COUNTY OF AMHERST

Site Plan Review Staff Report – June 21, 2018

RE: Proposed Additions at Cooper Steel
Tax Map Parcel No. 137C3-A-4
273 Francis Avenue
Site Plan for additions to an existing manufacturing building in the M-1 Industrial District

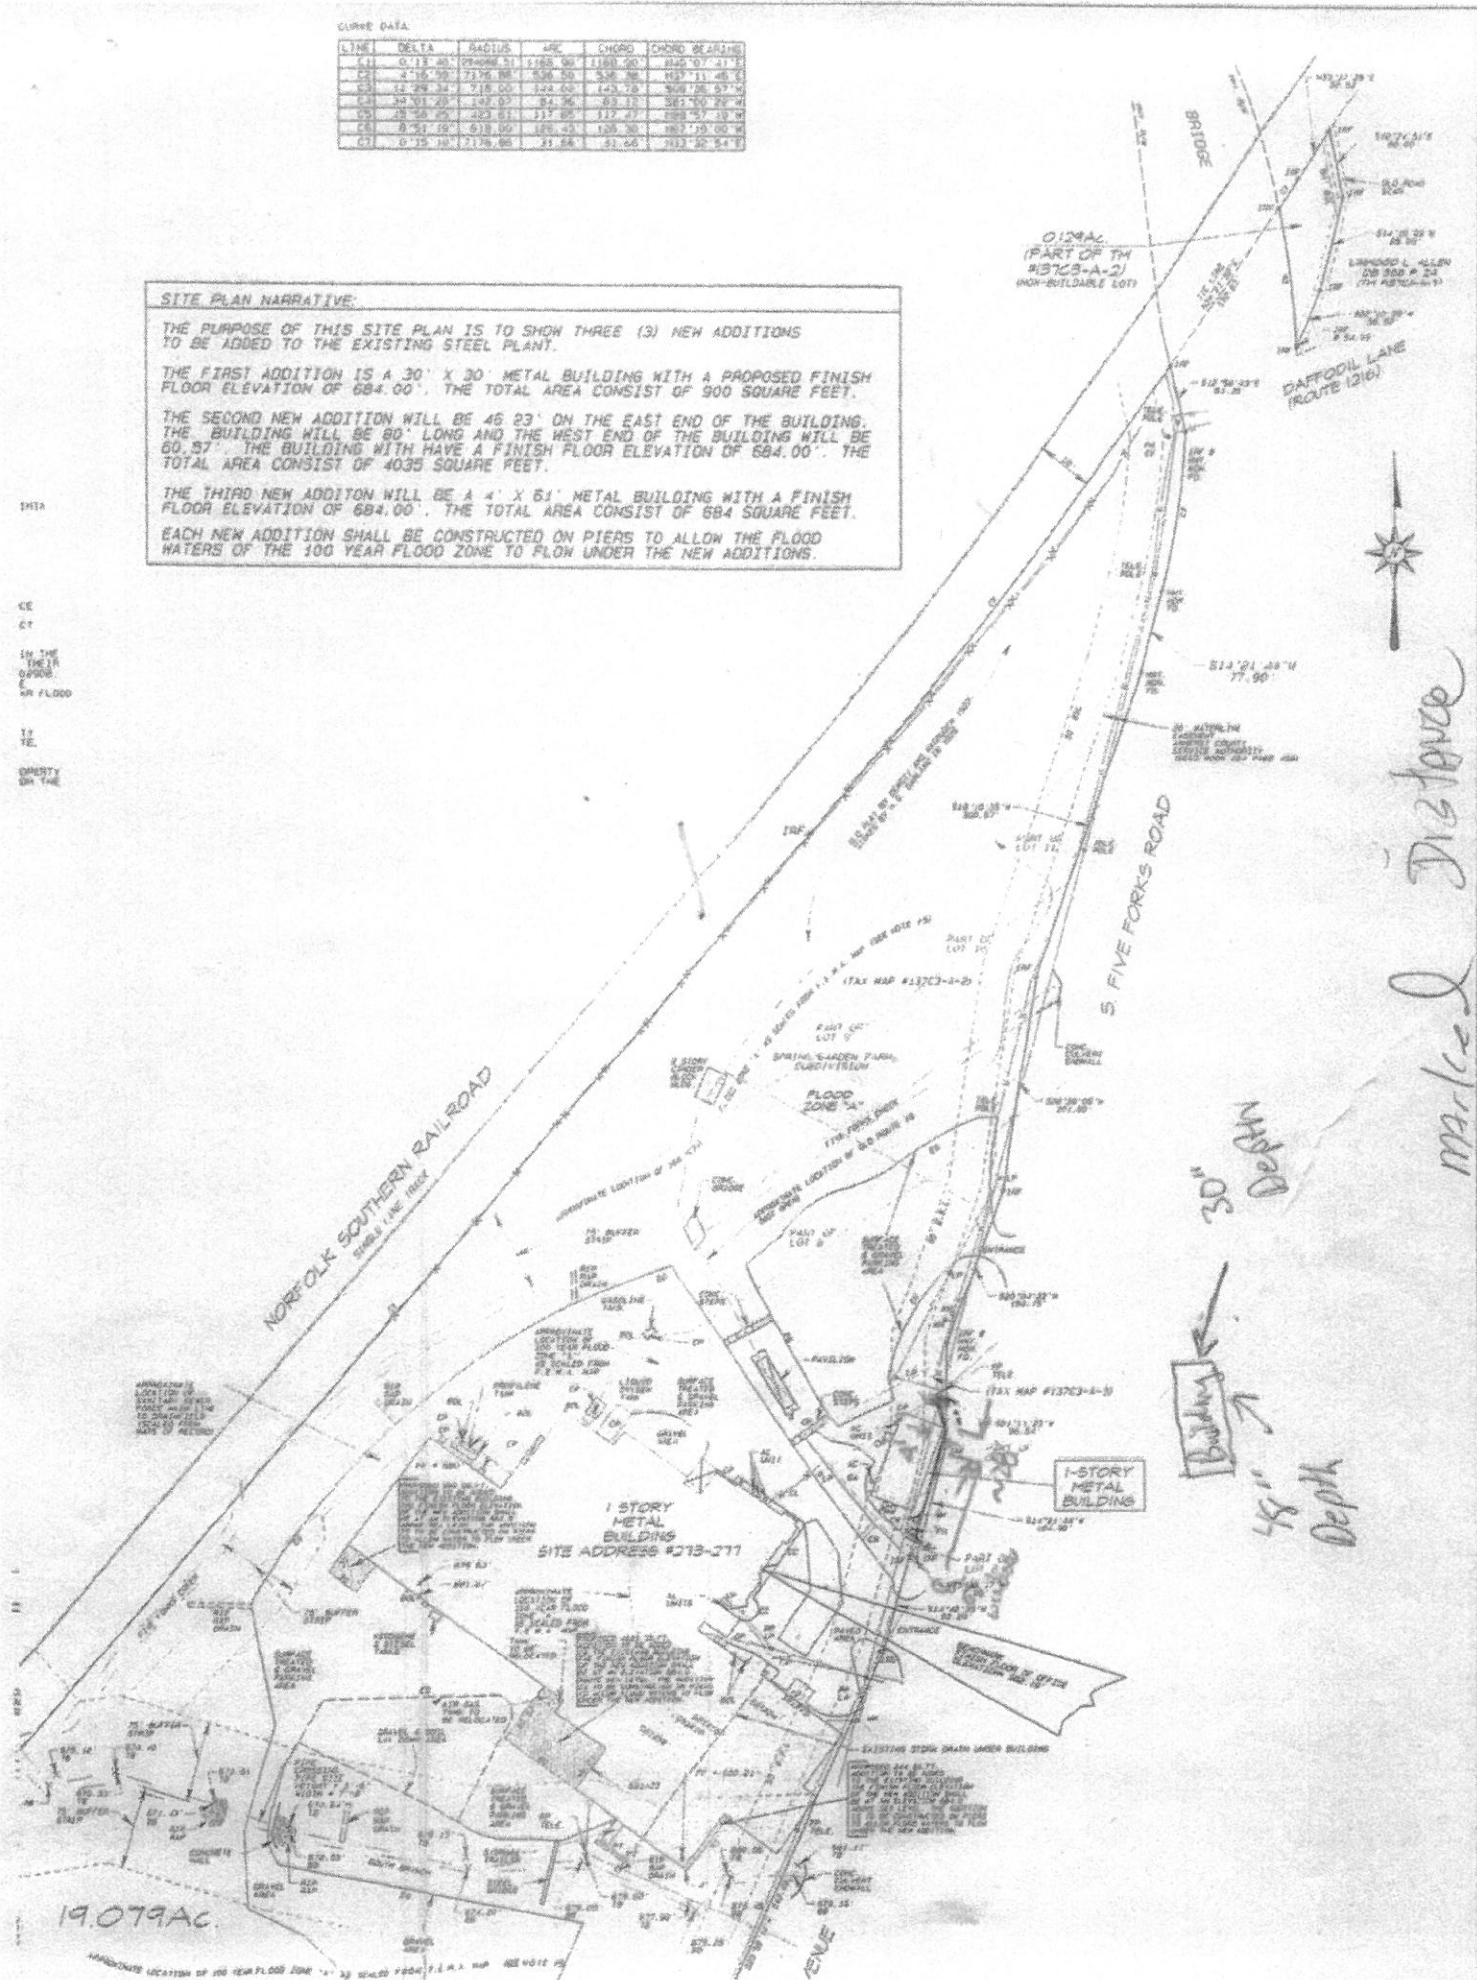
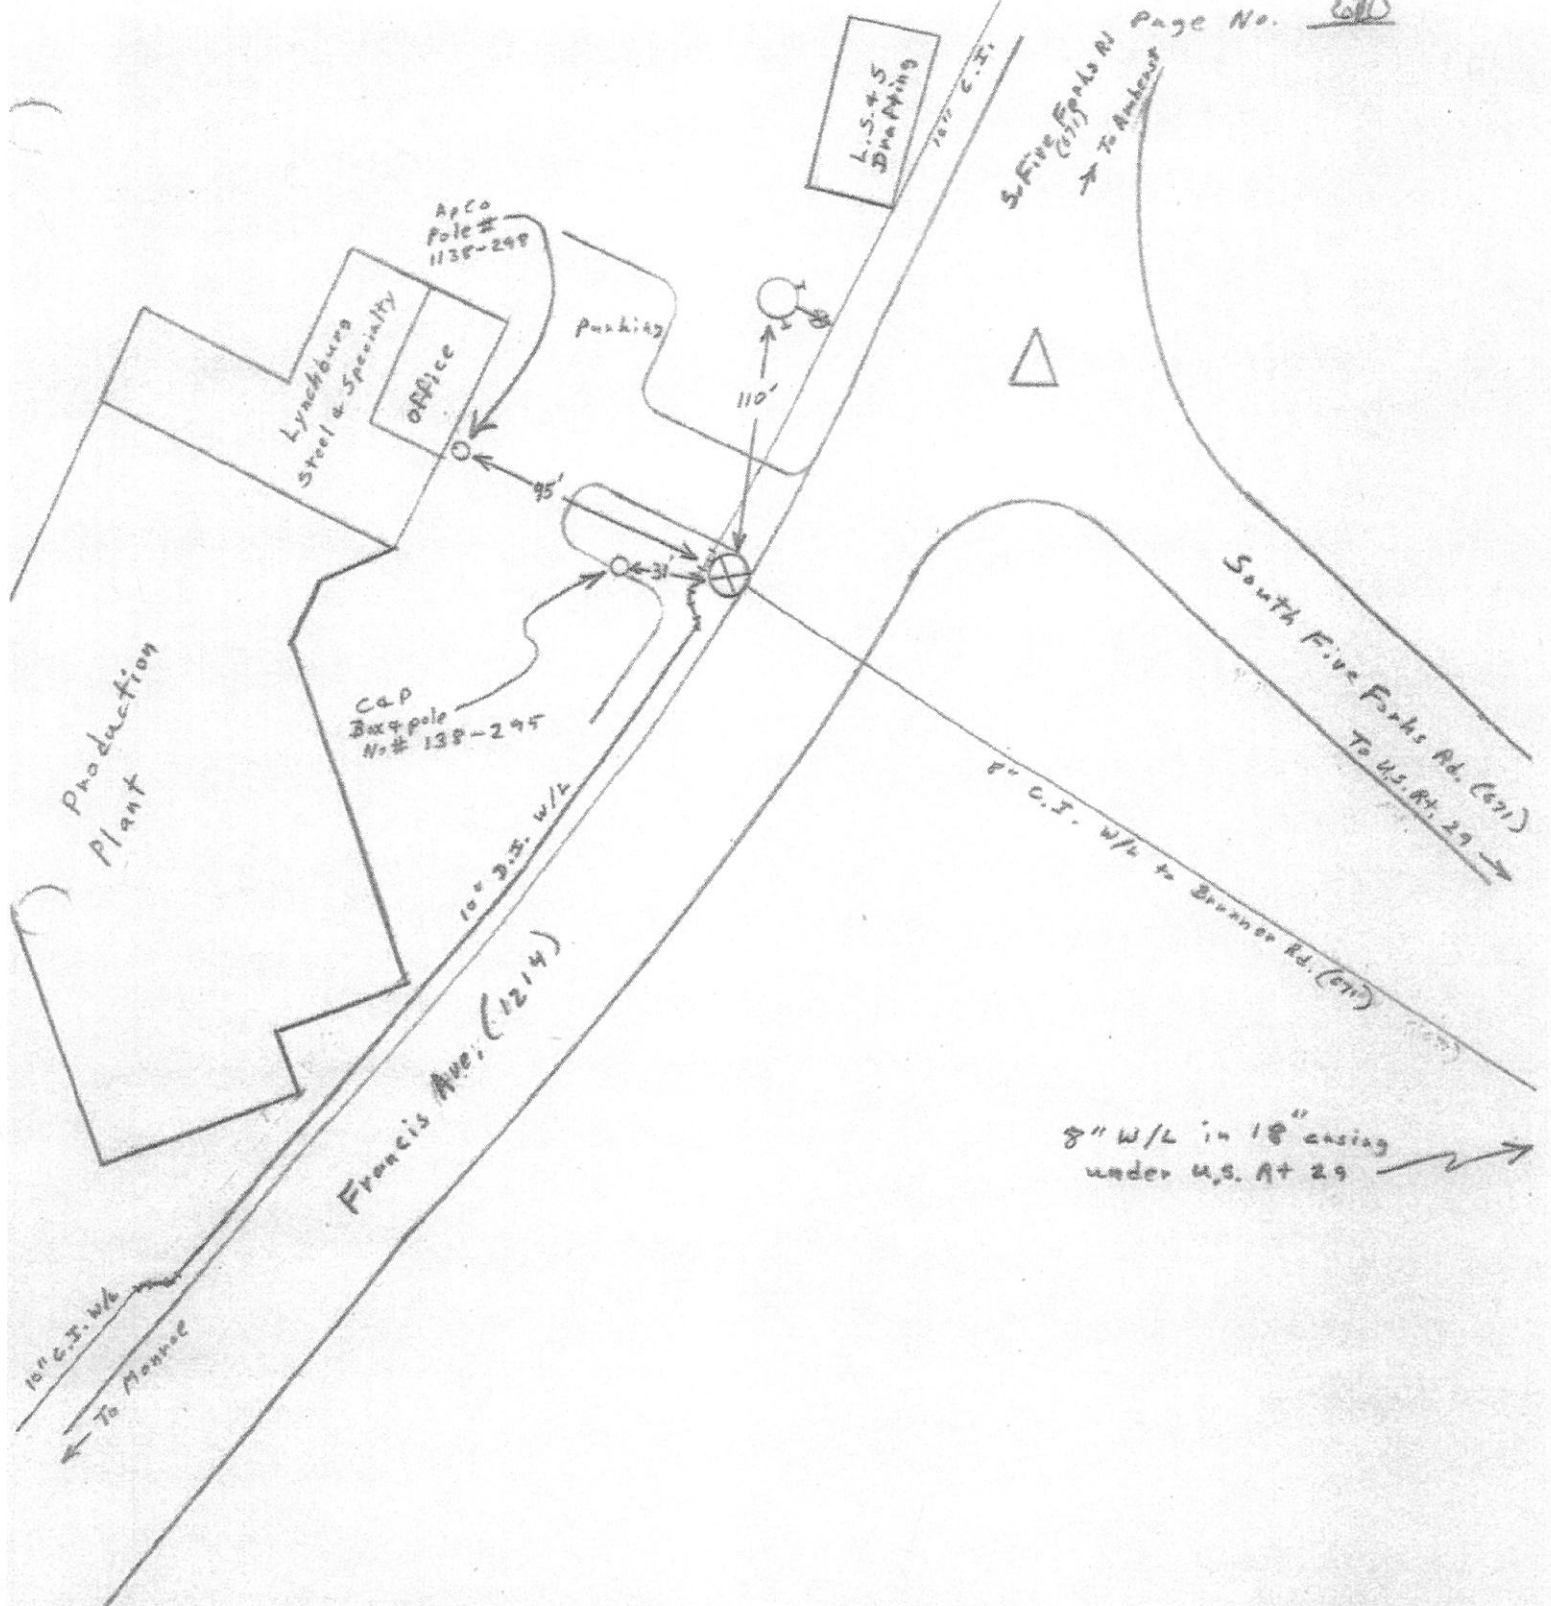
- Extensive site improvements, mostly existing, but also some proposed, are shown within the 75' stream protection buffers for South Branch and Five Forks Creek. The purpose of the buffers is to provide natural filtration of runoff, removing contaminants before the runoff enters the stream, to maintain water quality for treatment for potable consumption by the public. It is probably beyond reason to remove all of the improvements, but those that can be removed or secured to protect the streams, and should be, include the two propane tanks, the gasoline tank, and the storage trailer.

- The County Watershed Protection Ordinance which established the 75' stream protection buffers precludes building structures within the buffers, so the proposed addition on the southeast corner of the existing building, which is wholly within the buffer for South Branch, is prohibited.

- The large addition on the south side of the existing building protrudes into the South Branch buffer, but it maintains the existing building line, will be elevated above the known flood elevation and allow flood waters to flow/recede beneath it, and the encroachment is minimal, so no objection is noted.

- It is understood from yesterday's meeting that the large addition on the south side of the building will be used for truck loading and unloading. Provide the location(s) of the addition's overhead doors and show how the trucks will access the addition without entering the South Branch stream buffer.

3. ACSA records show a 10" diameter public water main within an ACSA easement along the site frontage. The pipe and easement are shown on the submittal, though the pipe is shown inaccurately. Post-meeting research revealed that the easement and water line pre-date the building and the building construction not only encroached into the water line easement, but resulted in a portion of the building resting atop the water line. Refer to the attached plan. The water main is not only large, but it is high pressure, it is cast iron, and it is several decades old. As cast iron pipe ages, its interior slowly corrodes and tuberculates, and its exterior gets brittle. The corrosion reduces the pipe wall thickness, the tuberculation increases turbulence inside the pipe, and the brittleness reduces the material strength. All of this increases the likelihood of a pipe failure, all of this will get worse over time, and all of this is exacerbated by a heavy dead load, like a building, sitting on top of it. While ACSA would have no liability for building, property, or road damage should the pipe burst, because of the easement encroachment, it is in the interest of both ACSA and Cooper Steel that this situation be corrected.

The water line needs to be relocated to maintain a minimum five feet (5') separation from the building, which will remedy the existing situation and provide sufficient access for ACSA pipe maintenance. Mr. Jeff Kessler, VA Dept. of Transportation, said at the DRC meeting that such a relocation could encroach into the VDOT right-of-way. ACSA is willing to engage a contractor to relocate the water line, using ductile iron pipe, and abandon in place the existing water line in the vicinity of the building, mostly at our cost, but will need Cooper Steel to participate as follows:

- (i.) Remove all fuel (diesel and kerosene) storage and propane tanks from the 75' buffer zone.
- (ii.) The storage trailer in question has been removed from the face of the building and relocated out of the 75' buffer zone already.
- (iii.) Changes are in process for the shop space work-flow.
- (iv.) The 4' x 60' addition will not be constructed.
- (v.) The 4035 square foot addition and 900 square foot addition will use flood control louvers allowing water to access and descend within the proposed addition without resistance. The site plan was revised and is attached.
- (vi.) The proposed 4035 square foot addition will contain 2 overhead doors on the northwest face of the building and the existing gravel drive that is currently used will be utilized for truck access. Two additional manned doors will be added to the plant.

(vii.) The existing propylene and carbon monoxide tanks will vaporize into the air in the event of a leak or flood. The propane tanks will be relocated as per our discussion at the Development Review Committee meeting.

(viii.) Secondary containment basins for diesel and for kerosene fuel storage required will be single wall tanks with metal roofs. Sides have been installed to eliminate the access of rain water.

Cooper Steel has no plans to participate in the relocation or installation of a new waterline. Cooper Steel will indemnify Amherst County Service Authority and Amherst County for any damages to the building caused by future repairs to the existing water line.
